VARIANCE APPLICATION

Response to Comments - Variance (2/7/23)

STAFF REPORT

The applicant is requesting approval of Final Development Plan, Design Review, Conditional Use, and Variance applications for a new storage garage and gravel lot for a landscaping company at 6301 Taylor Road. The property is currently zoned OCT — Office, Commerce, and Technology. This zoning designates the site as part of Design Review District 4 (DRD-4).

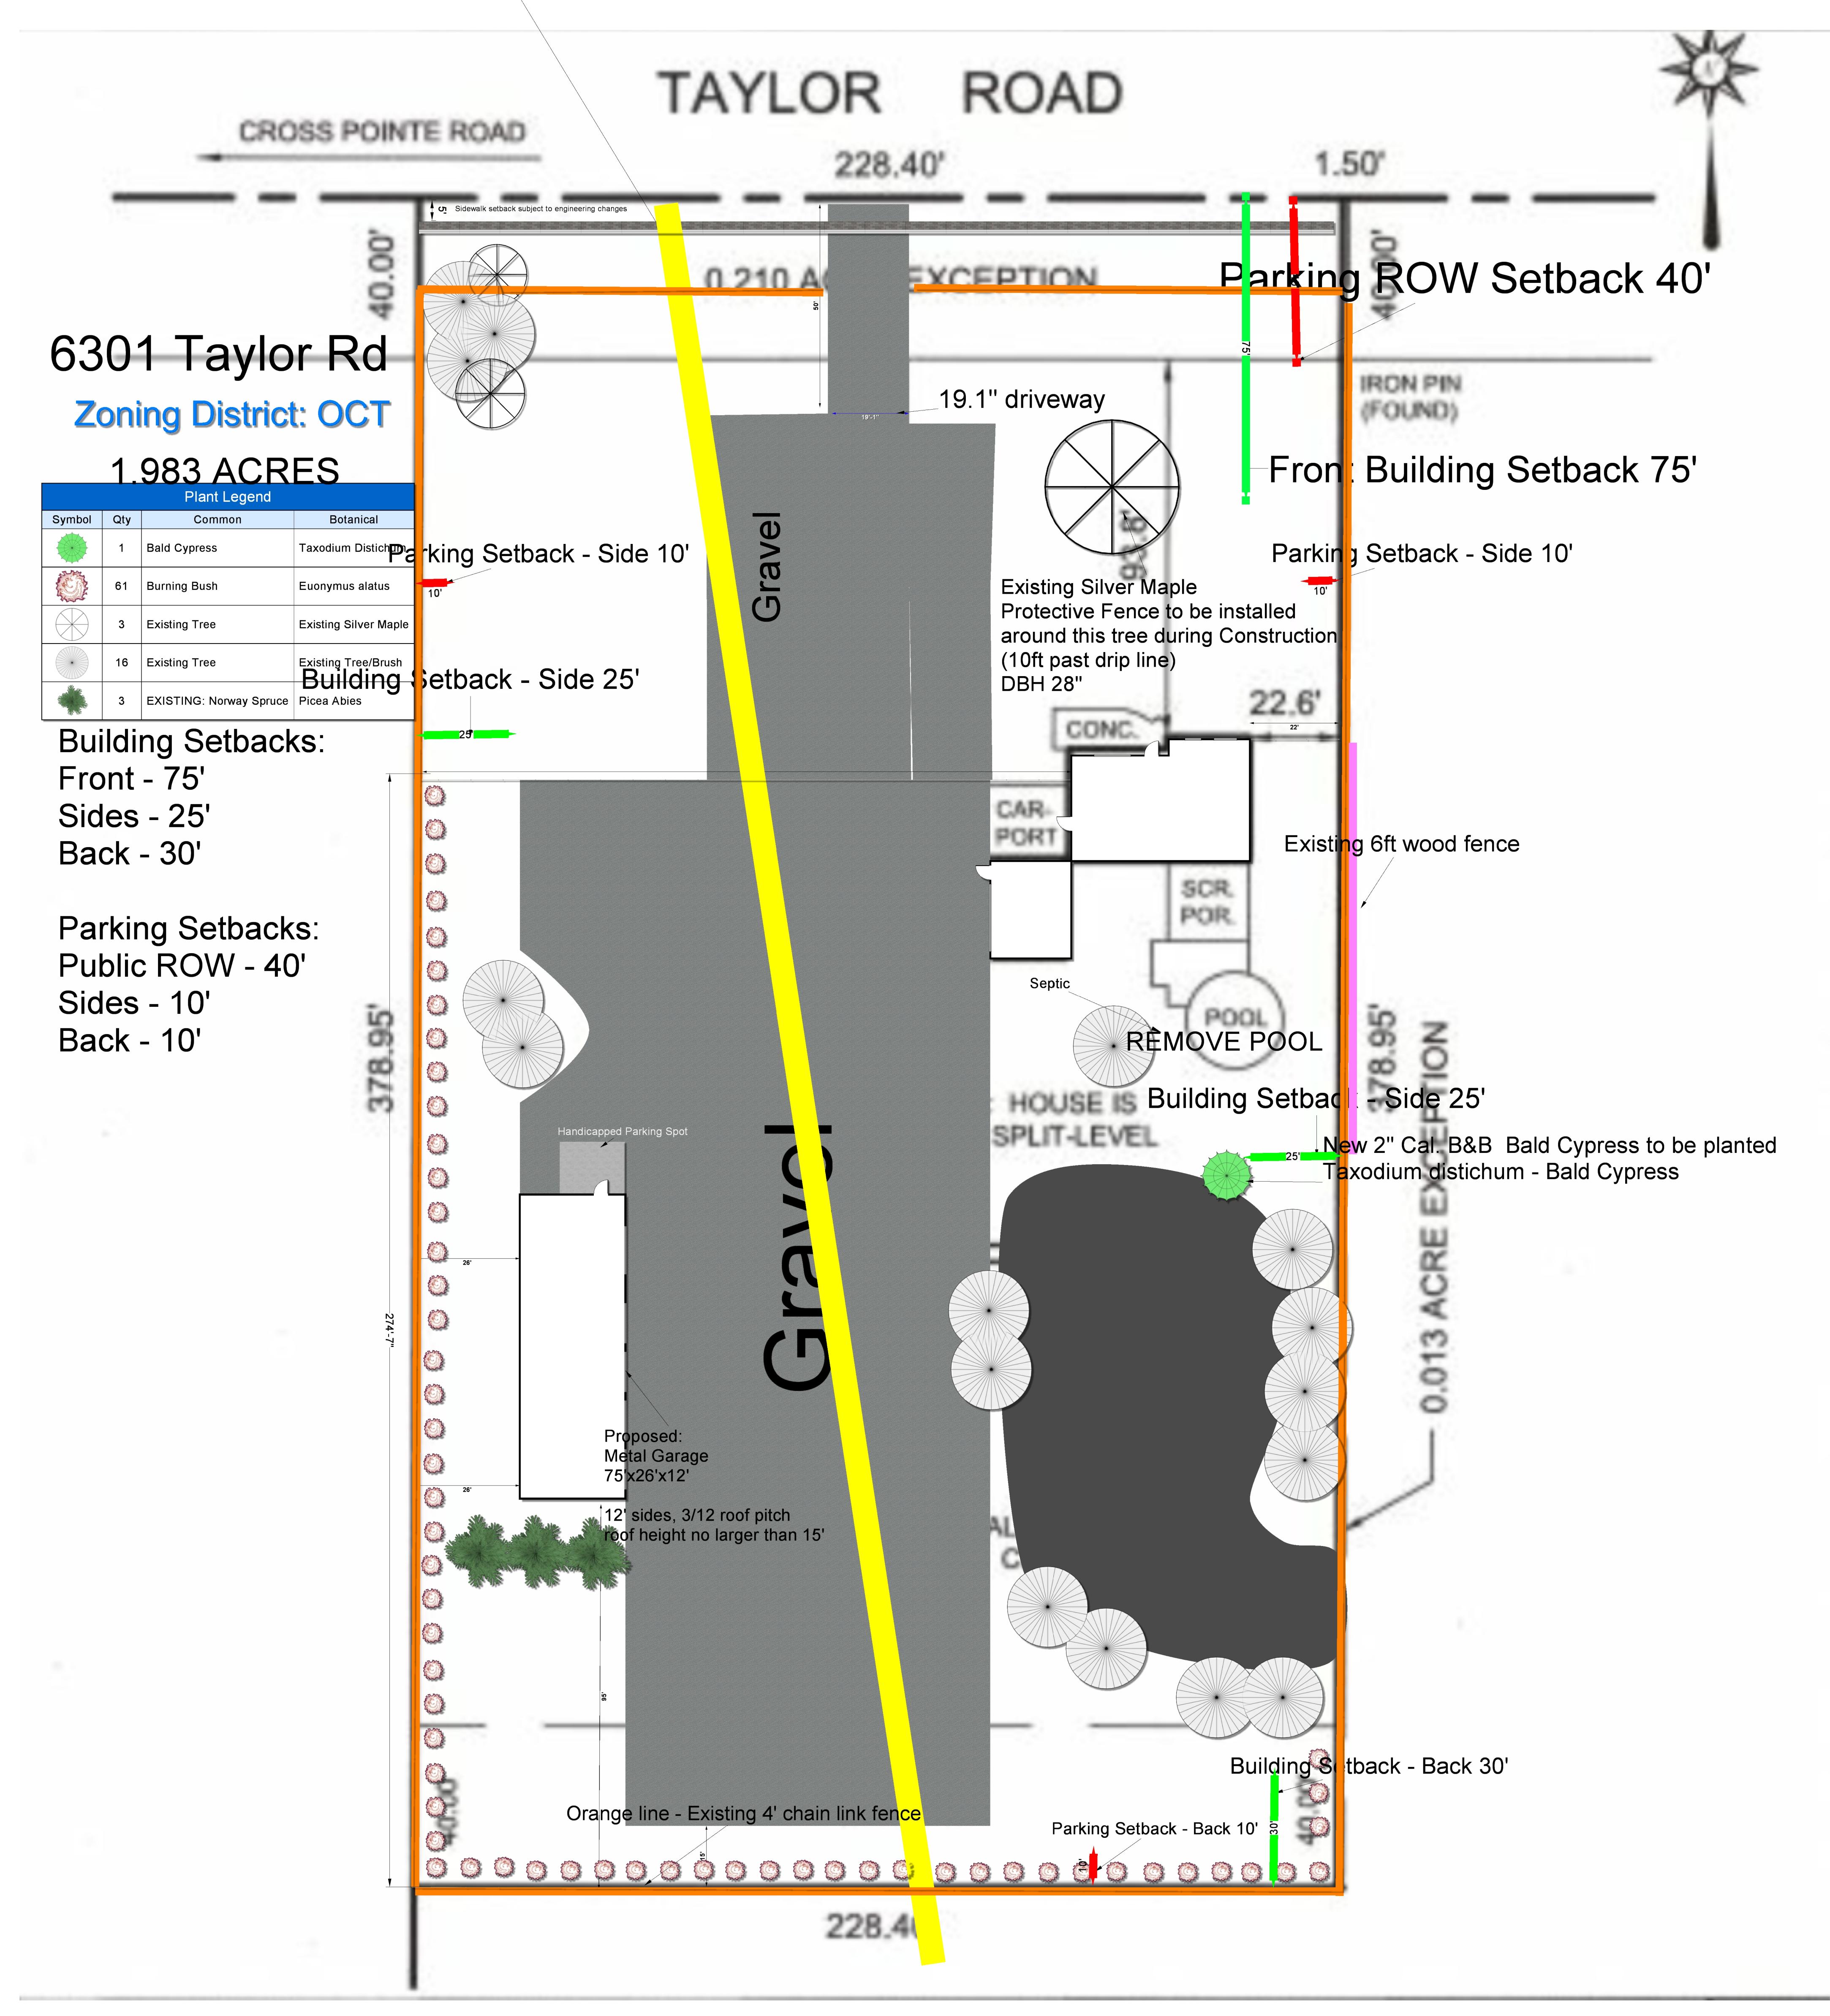
I/WE CERTIFY THAT I/WE HAVE EXAMINED THE SURVEY FOR SCALE: 1"=60" THE PROPERTY THAT IWE HAVE JUST PURCHASED AND IWE ACKNOWLEDGE RECEIPT OF A COPY OF SAID SURVEY. ROAD **TAYLOR CROSS POINTE ROAD** 1.50 228.40 40.00 40.00 0.210 ACRE EXCEPTION IRON PIN (FOUND) 93.8 22.6 CONC. GRAVEL 24.0° 20.4° 1 6301 g DRIVE CAR-20.05 22.55 22.55 SCR. POOL 378.95 0.013 ACRE EXCEPTION NOTE: HOUSE IS FRAME FRAME SPLIT-LEVEL SHED 1.983 ACRES TRACT I ALL FENCE IS CHAINLINK 228,40
